Access Compliance Report

Public Rights-of-Way

(Curb Ramps)

Intersection ID: 5858	Main Street: CARMENET_LN	Cross Street: LONG_PAW_LN	Location: NE
ADA ID: 9D0E9D1EE911	Ramp Type: PerpDiag	Initial Pass/Fail: Fail	Overall Compliance: No
			Severity Score: 33.75

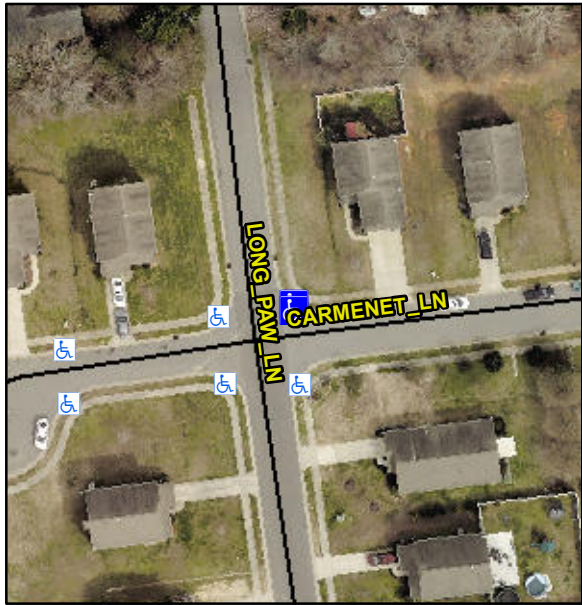
Codes/Mitigation Info/Possible Solution			Field Measurements/Component Compliance					
	Possible Solutions:		Compliance	Description	Data	Compliance	Description	Data
	Remove & Replace Curb Ramp With Two New Directional Ramps or Equivalent.		N/A	Ramp Length (in)	51.0	No	Ramp Slope (%)	9.6
			No	Ramp Width (in)	43.0	No	Ramp XSlope (%)	5.4
			N/A	Flare Type LT	N/A	N/A	Flare Type RT	N/A
			N/A	Flare Slope LT (%)	N/A	N/A	Flare Slope RT (%)	N/A
			N/A	Flare Traversable LT?	N/A	N/A	Flare Traversable RT?	N/A
			N/A	Landing Length (in)	N/A	N/A	DWS Provided?	N/A
			N/A	Landing Width (in)	N/A	N/A	DWS Contrast?	N/A
			N/A	Landing Slope (%)	N/A	N/A	DWS Length (in)	N/A
			N/A	Landing X Slope (%)	N/A	N/A	DWS Full Width?	N/A
	Surveyor Notes:		N/A	Landing Curb? (Y/N)	N/A	N/A	DWS Offset (in)	N/A
	PROW/ADA:		N/A	Shared Landing?	N/A			
	Not Found, R304.5.1, R304.2.2, R304.5.3		N/A	Gutter Ponding?	N/A	N/A	Gutter Slope (%)	N/A

N/A	Gutter Lip Ht (in)	N/A	N/A	Gutter X Slope (%)	N/A
			N/A	Painted X Walk1?	No	N/A	Painted X Walk2?	No
				X Walk 1 Direction	To N		X Walk 2 Direction	To W
			N/A	X Walk 1 Width (in)	N/A	N/A	X Walk 2 Width (in)	N/A
				X Walk 1 Slope (%)	4.3		X Walk 2 Slope (%)	0.7
				X Walk 1 X Slope (%)	3.6		X Walk 2 X Slope (%)	3.0
			N/A	Ramp inside XWalk1?	N/A	N/A	Ramp inside XWalk2?	N/A
			Road Slope (%)	4.5	N/A	Clear Space?	N/A	
			Road X Slope (%)	1.4	N/A	Clear Space to XWalk (in)	N/A	
		N/A	Any Obstructions?	N/A	N/A	Storm Grate/Utility Hazard?	N/A	
			Obstruction Type			Storm Grate/Utility Type		
					N/A			N/A
					Yes	Surface Condition? (G/P)	Good
